**DA-836/2020 – Phase A Detailed DA
Response to request for additional information
Liverpool Civic Place, 52 Scott Street and 306-310 Macquarie Street, Liverpool**

Attachment A – Detailed response to Architectus’ request for additional information DA/836/2020 Liverpool Civic Place

**RE: Liverpool Civic Place – Phase A
Response to Council RFI – Acoustic & Vibration**

CGI excerpt; view from Scott Street looking southwest toward the proposed primary lobby with shared zone in foreground

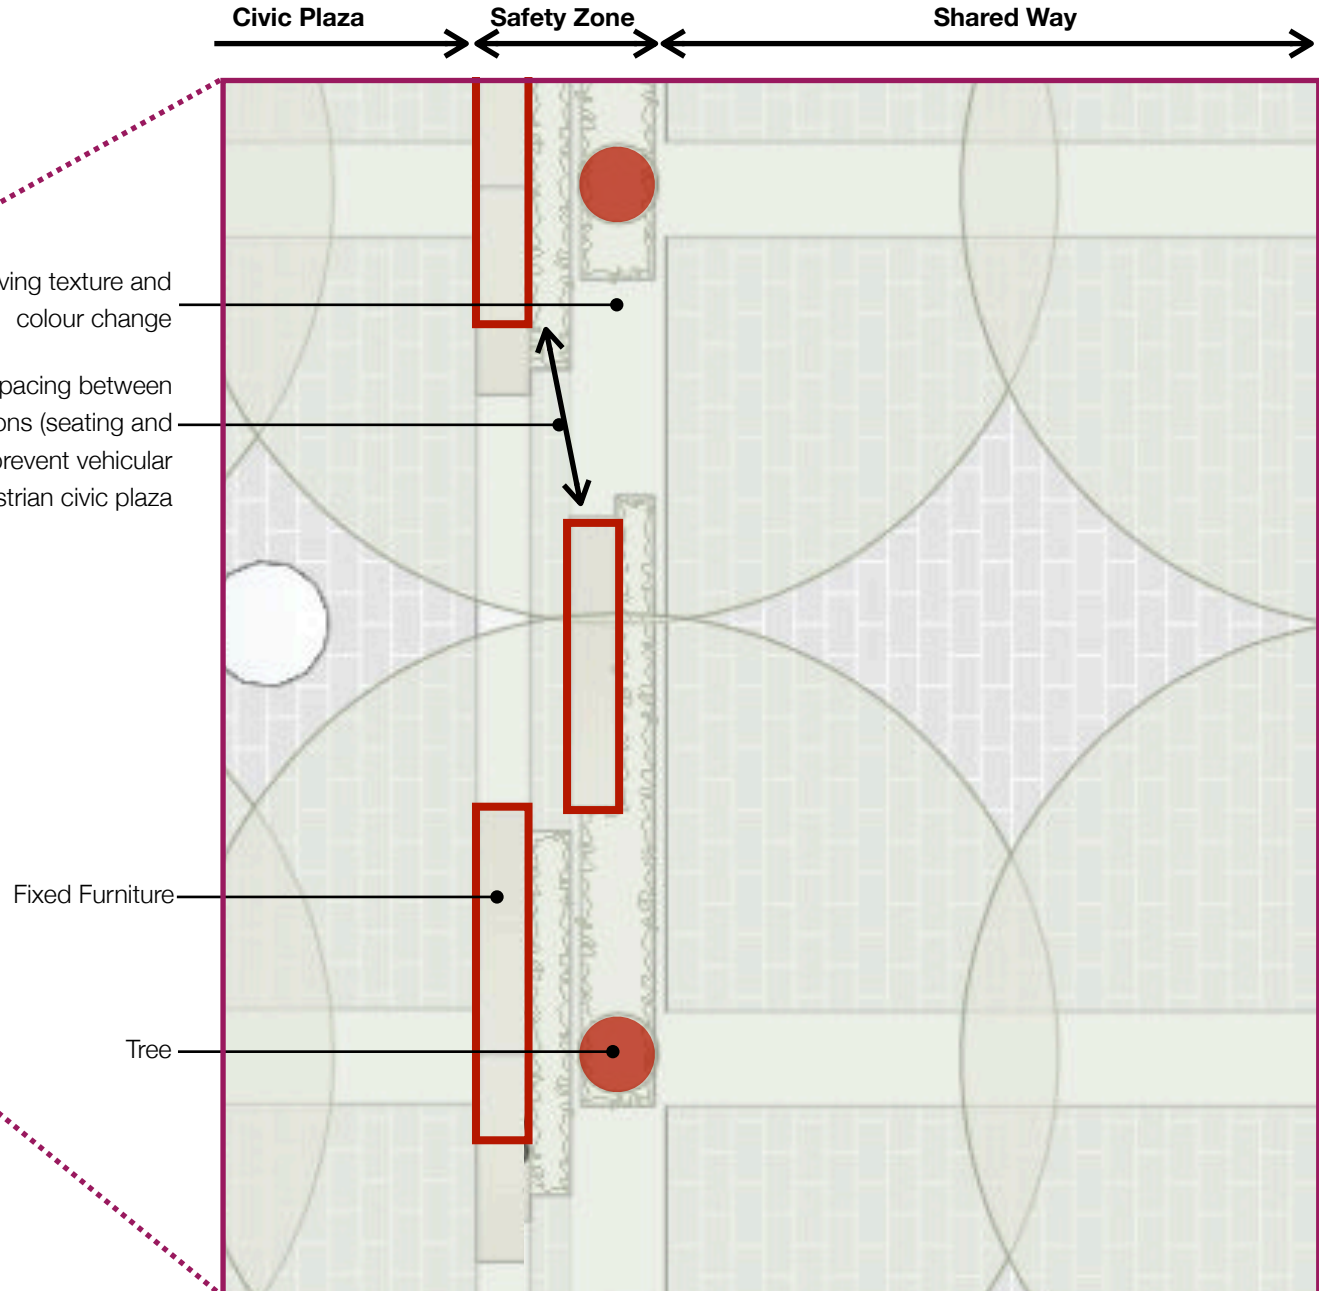
The Panel notes that there will be potential conflicts with pedestrians and cars entering the shared way. The Panel recommends the applicant to consider appropriate measures to ensure that future conflicts are reduced. The Panel recommends Council to review the traffic arrangements thoroughly at the approval stage to ensure there are no conflicts; and a traffic management plan is implemented. **(Refer 2F(i))**

Floor plan excerpts adjacent seek to illustrate passive safety measures; with no space greater than 1800mm between obstructions and variations in surface material textures and colours.
